# Value Analysis Study

## Buckeye Area Drainage Master Plan Flood Control District Maricopa County, Arizona

## Value Analysis Final Report

# Sketch Worksheet

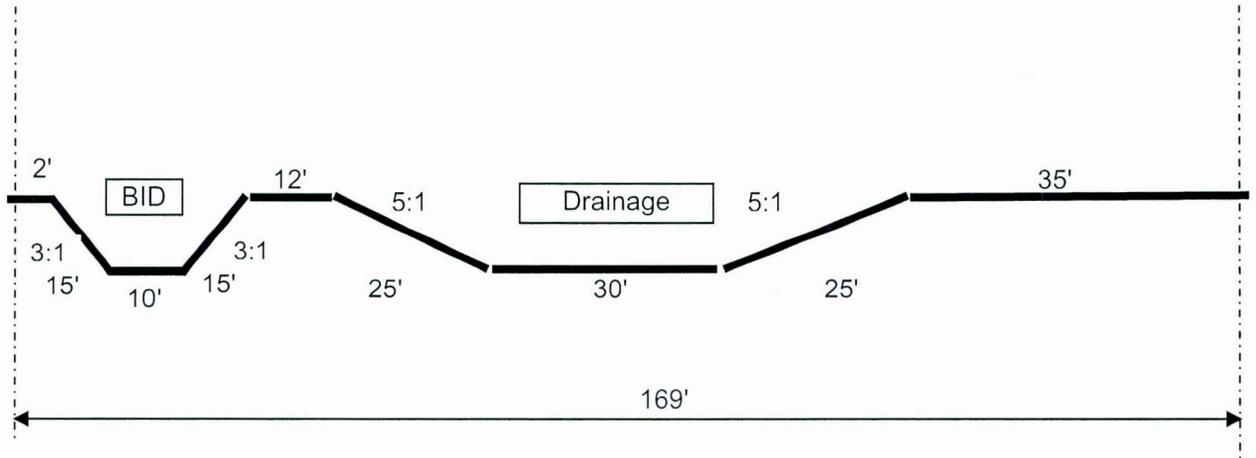
Build Drainage channel on North side of BID without encroaching the BID canal. APS line is also a potential conflict.

With an agreement between the BID/TOB/FCDMC, utilize BID's existing ROW and reconstruct their irrigation canal to the far south side allowing gravity flow and service to their customers while building the drainage channel on the North side & confining it to 169' max ROW, keeping the APS line as horizontal control, and acquiring the extra ROW needed. An increase of basin acreage with offline design would be necessary.

# Sketch Worksheet

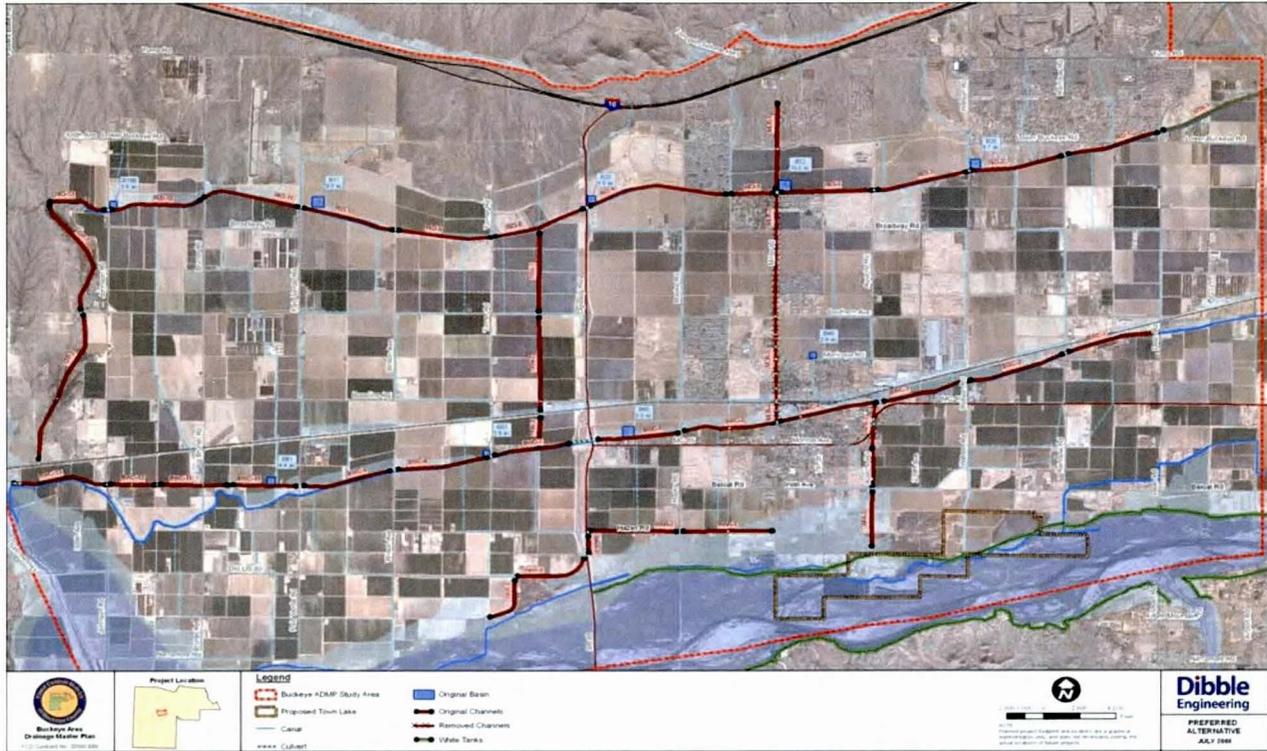
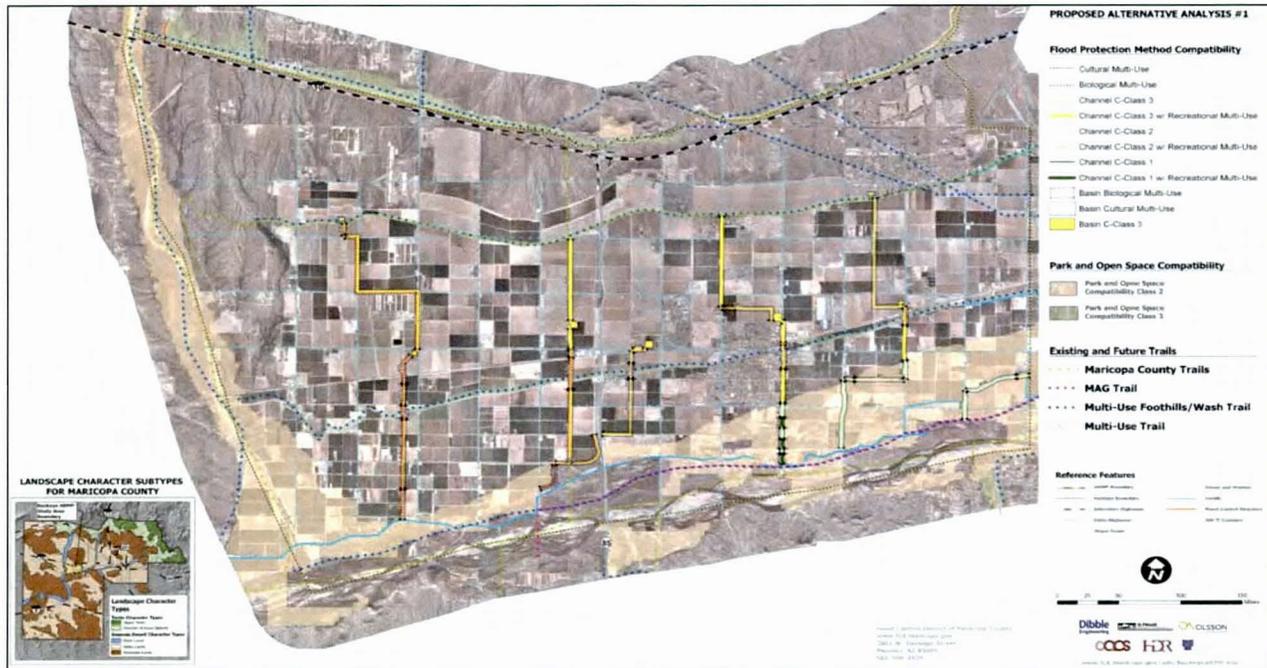
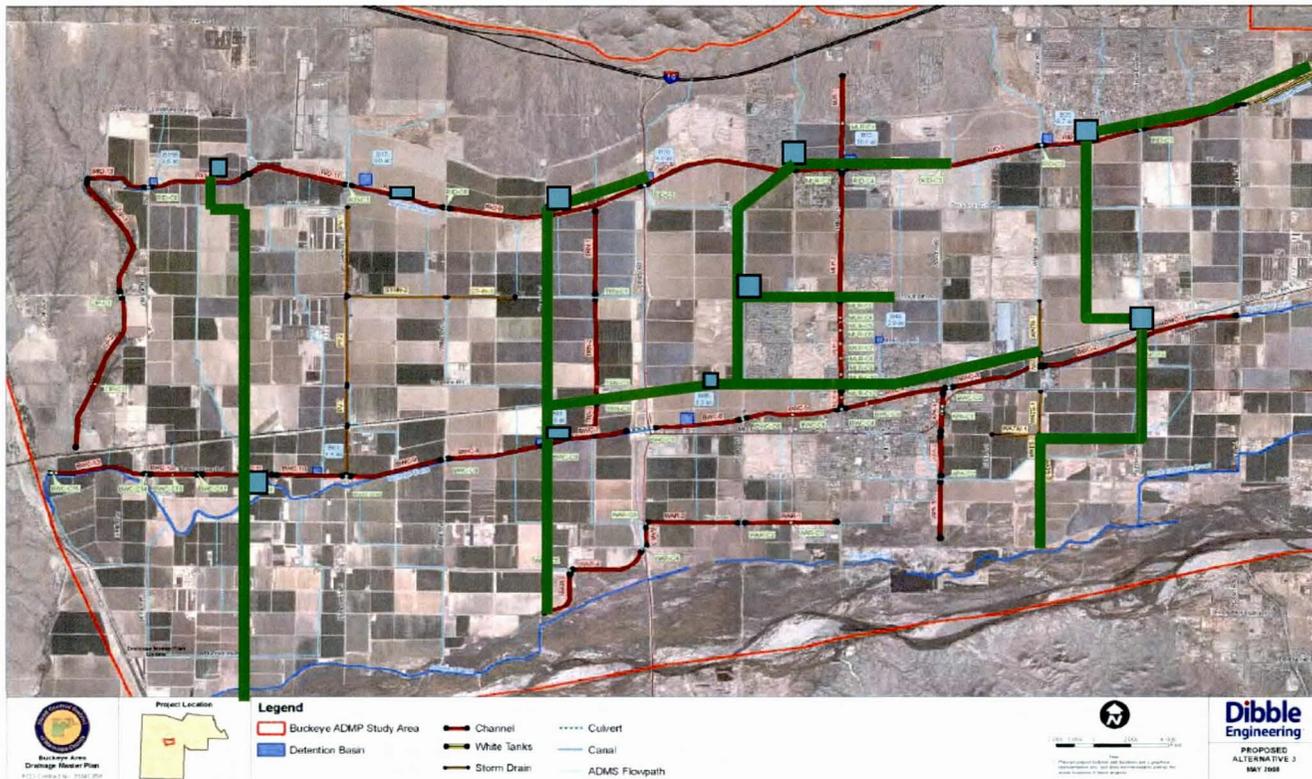
East-west collector channels and basins located along canal to pick up flows and minimize canal crossings with major north-south channels carrying flows to Gila River. Upstream basins attenuate flows to reduce size of north-south channels and size of canal crossing. East-west channels are provided along Southern Ave. and the Union Pacific Railroad to protect Central Buckeye, including the Rodeo Grounds. Flows from White Tanks FRS 4 are picked up at RID canal location.

- Cross RID, BID, Railroad, and APS Palo Verde water line 3 times
- Outfalls into town lake project area
- Potential for not reducing floodplain along BID (specifically between Turner and Palo Verde roads)

# Sketch Worksheet

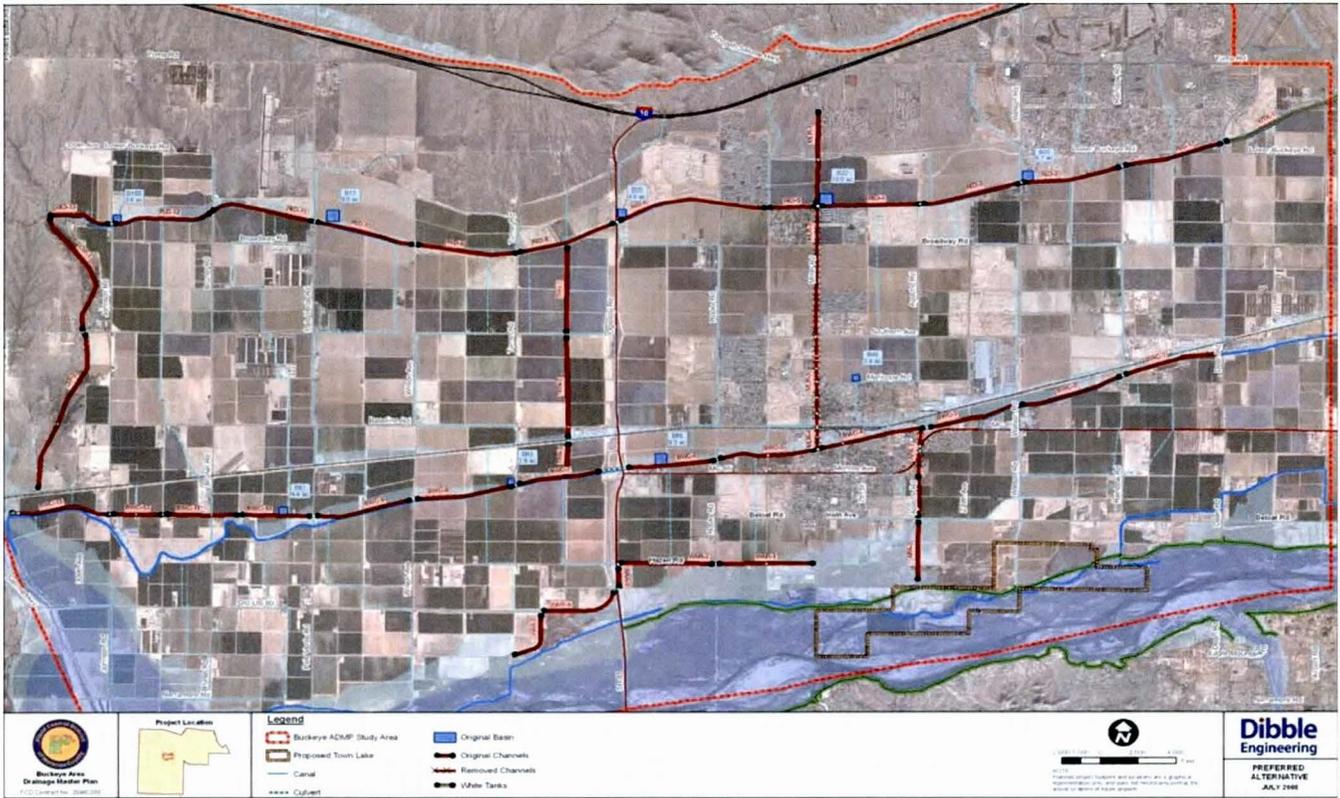
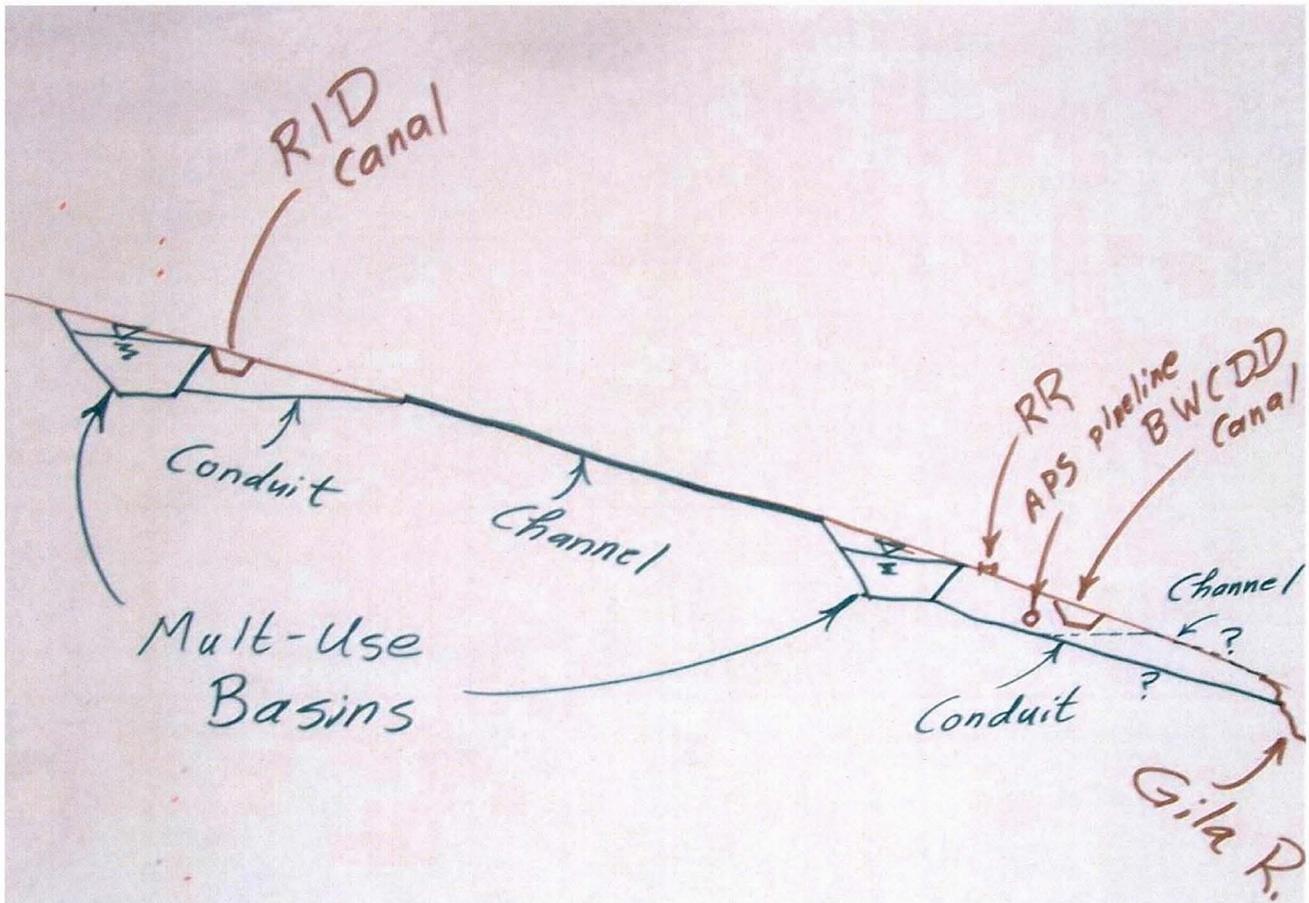
Utilize north/south channel alignments as shown by Alternative 1. Approximate length of channels is 24.6 miles. Consider utilizing additional basins north of the RID and enlarge planned basins to enhance attenuate of peak discharge flows. Basin modifications as stated would allow for reduced channel and culvert sizing; and, enhance constructability of crossings of the APS pipeline, BWCDD, Union Pacific Railroad. Also, reduce channel cross section be eliminating one O&M road/trail and reduce landscape buffer adjacent to arterial roads. In order to eliminate one crossing of the APS pipeline, realign channel segments identified by Alternative 1 as R21 and R22 to connect to the south end of segment R25. Also, provide multi-use within planned basins that had been shown without multi-use.

**TYPICAL SECTION - SMALL REGIONAL CHANNEL (40'-80' CHANNEL WIDTH) NOT TO SCALE**

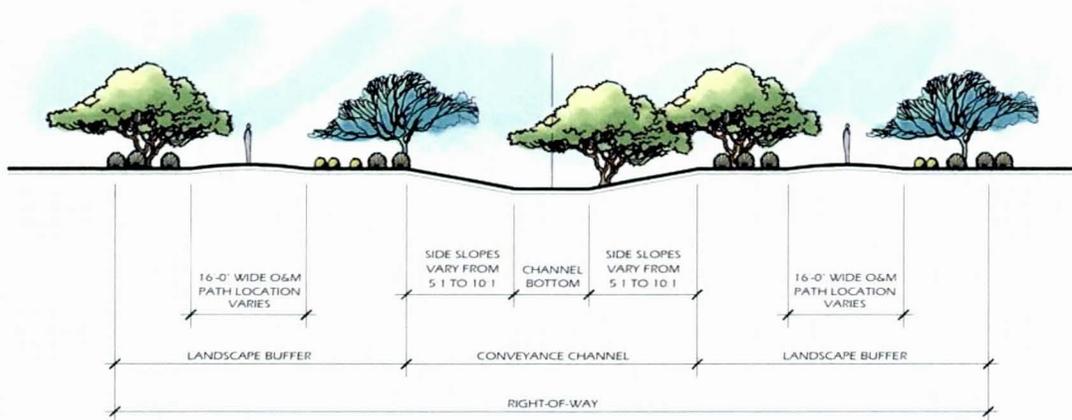
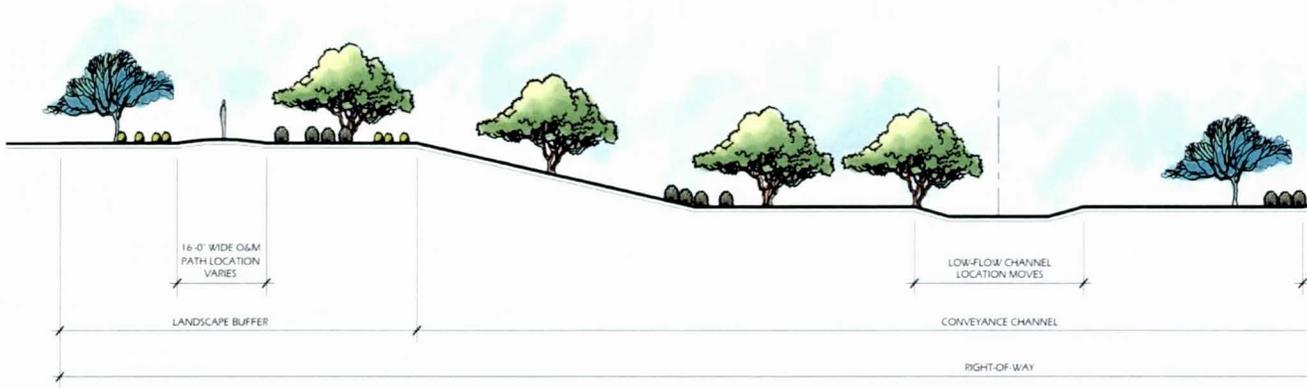
- Reduces land acquisition cost
- Less O & M cost
- Improves opportunity to implement plan
- Reduced impact to adjacent land owners
-

# Sketch Worksheet

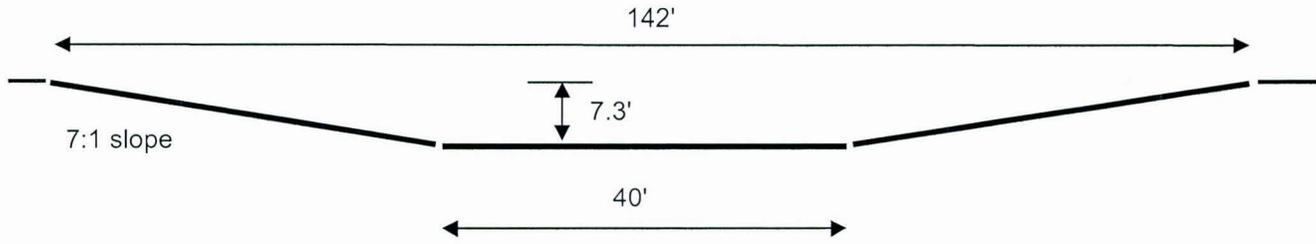
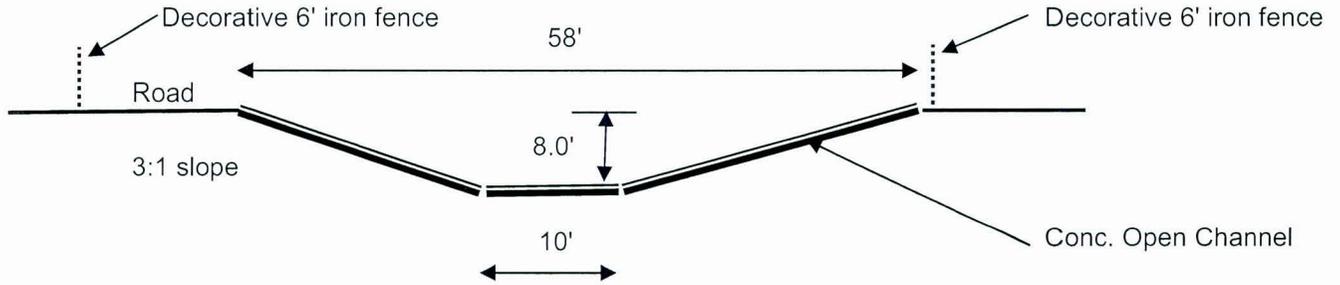
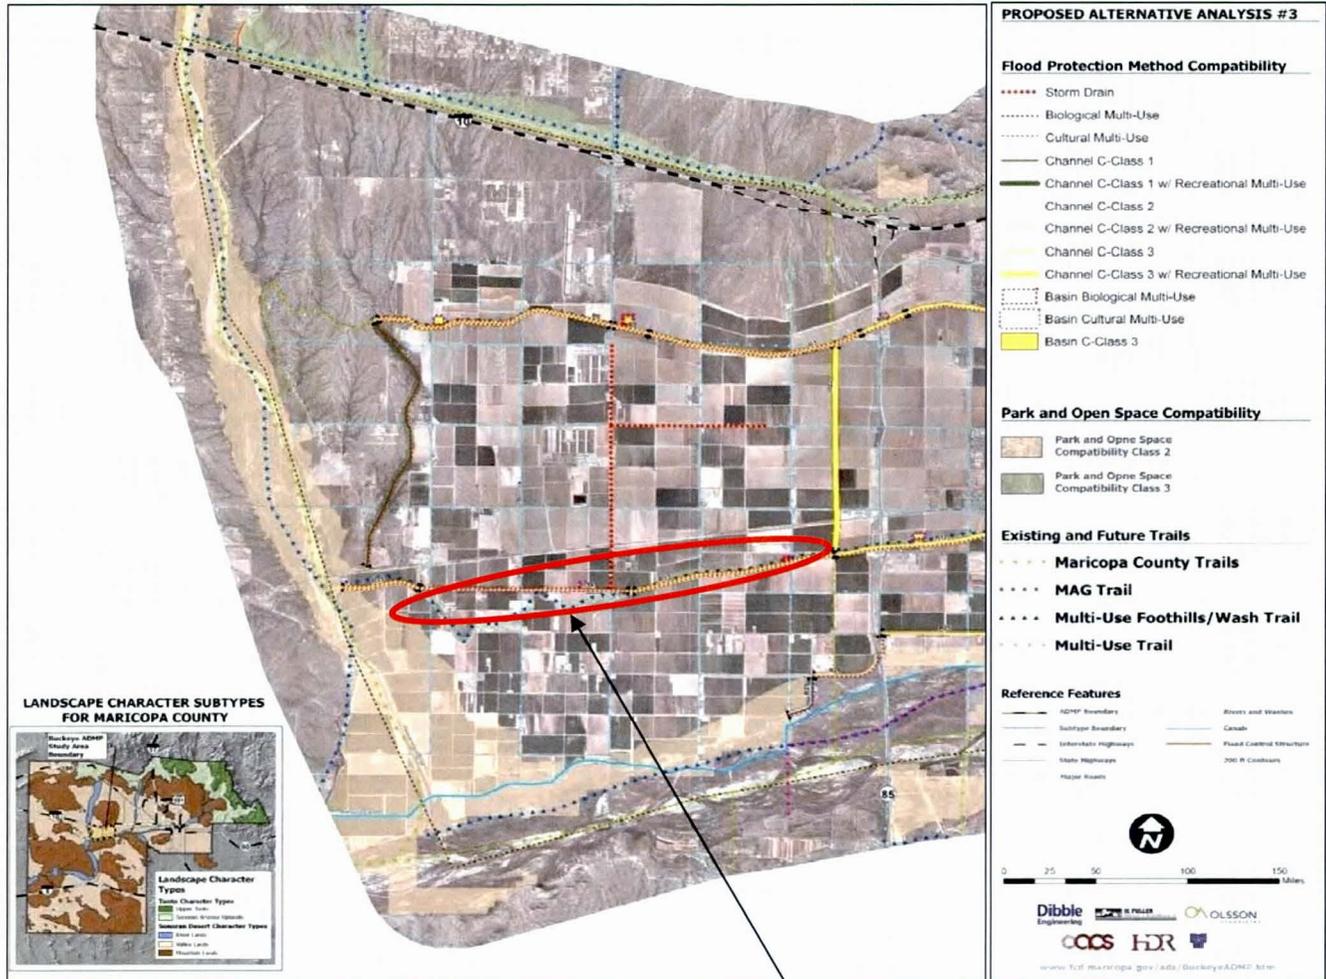
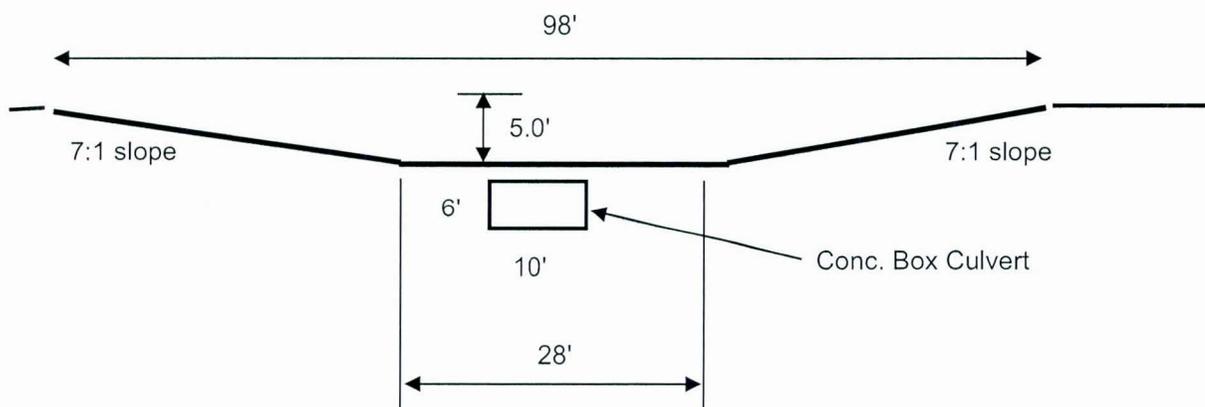
- Reduces land acquisition cost
- Less O & M cost
- Improves opportunity to implement plan
- Reduced impact to adjacent land owners
- Additional access to railroad spurs

# Sketch Worksheet

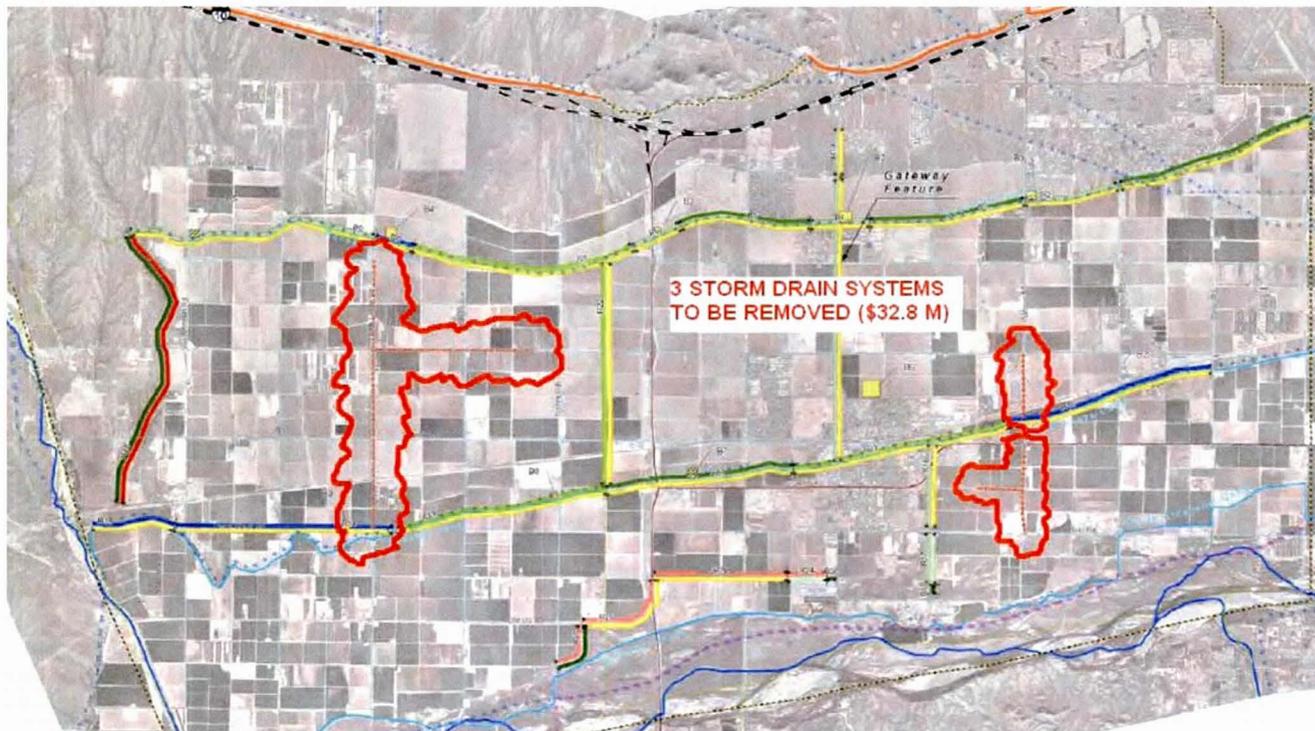
Three storm drain systems were originally planned for Alternative 3.

Storm drains should be part of local improvements (10 year design). Remove storm drains from regional master plan.

Storm drains will be added to street infrastructure as site development occurs. Storm drains for local drainage shouldn't be part of regional plan.

VA No.  
27

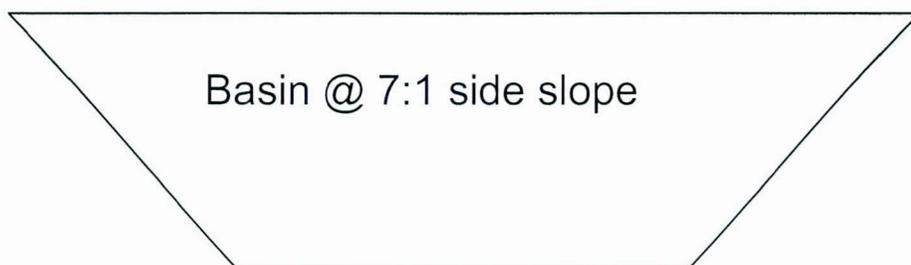
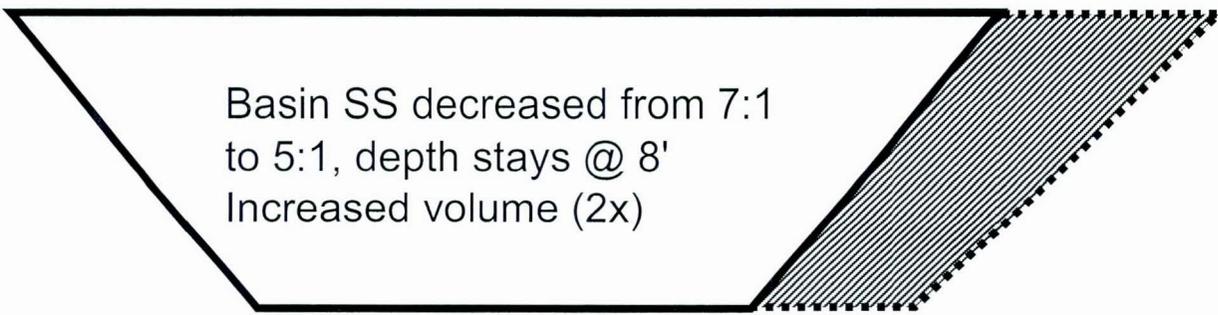
VA-25	Include storm drains as part of local improvements (10 year design) and remove storm drains from regional plan.		-						32,824,400	32,824,400	Yes, Storm drains will be removed from plan
VA-27	Optimize Basin - Channel relationship to reduce land cost		+	+					9,009,500	9,563,300	Yes, will work with Town of Buckeye parks to identify optimum size for parks and then develop basin size accordingly with hydrology and channel sizing.
